**MSOX4054A-01**

**S E R V I C E N O T E**

4000 X-Series Scopes

**A replacement of the power supply cover is needed when the cabinet assembly is replaced.**

New revision cabinet assembly (54709-64401)

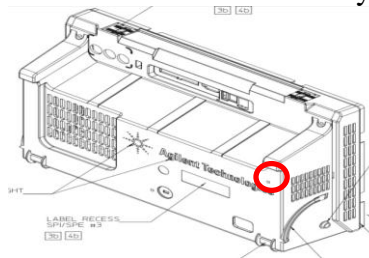
2. If the cabinet assembly is the new revision, proceed with repair as normal
3. If the cabinet assembly is the old revision
  - a. Replace the power supply cover (54695-00103) with new revision
  - b. Replace cabinet assembly as usual (54709-64401)
  - c. Insert screw (0515-0380) into the new screw hole on the cabinet assembly (circled below)
